CHANGE ORDER NO.: 1

Owner: **City of Breckenridge**
 Engineer: **eHT**
 Contractor: **Leetech Solutions**
 Project: **FM 3099 Utility Relocation**
 Contract Name: **N/A**
 Date Issued: **05/22/23**

WORK CHANGE DIRECTIVE NO.: 1

Owner: City of Breckenridge
Engineer: Enprotec /Hibbs & Todd
Contractor: Leetech Solutions, LLC.
Project: TXDOT FM 3099 Realignment Utility Relocation

PROJECT NO.:
5580-36
 SHEET No.
05

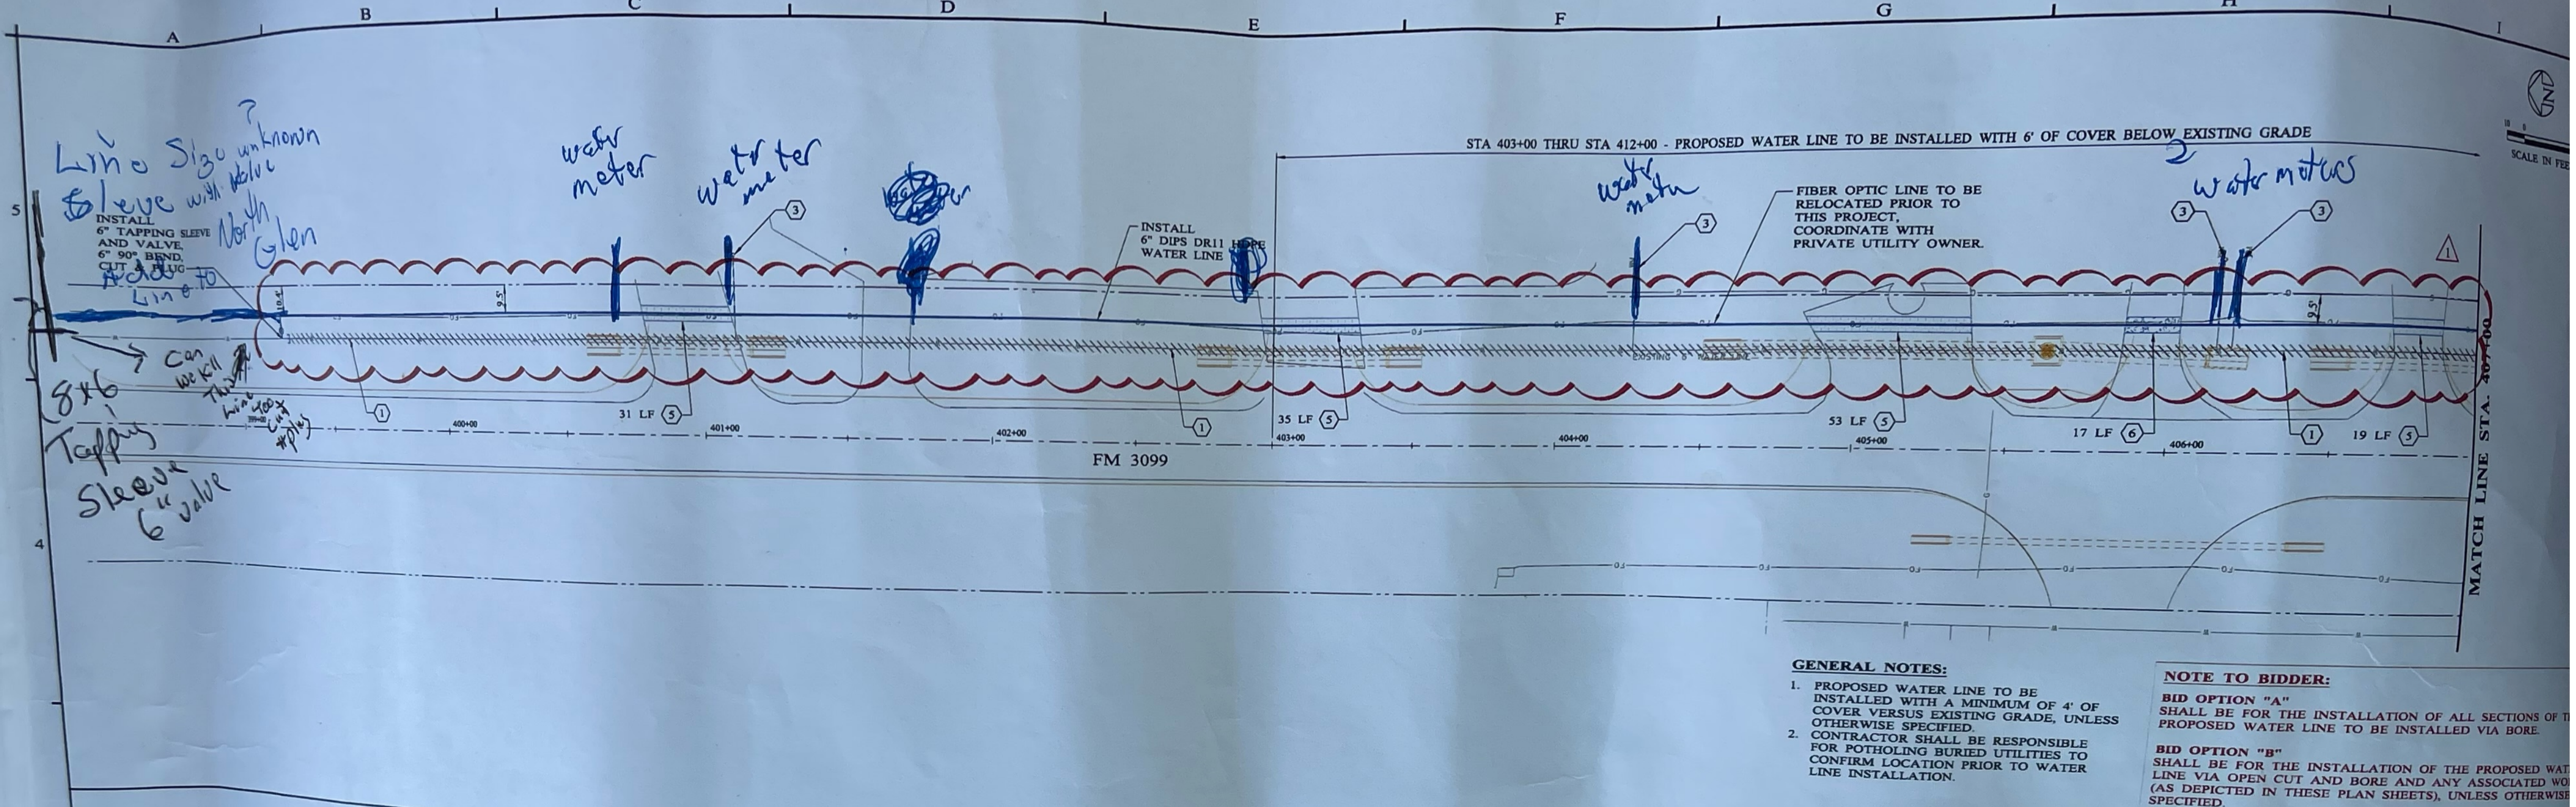
- Installation of 4" DIPS DR11 HDPE water line along the south side of Highway 180 to approx. STA. 464+61.
- Installation of 4" Gate Valve on each side of encasement below future FM 3099 roadway, south of Highway 180.
- Installation 4" DIPS DR11 HDPE water line inside of 185 linear feet of 6" HDPE casing below future FM 3099 roadway, south of Highway 180.

Revised Sheets 05 and 07.

The purpose for additional relocation is to avoid conflict with proposed TXDOT roadway improvements. The additional gate valves were requested by the City of Breckenridge. The reduction to encasement length was permitted by TXDOT.
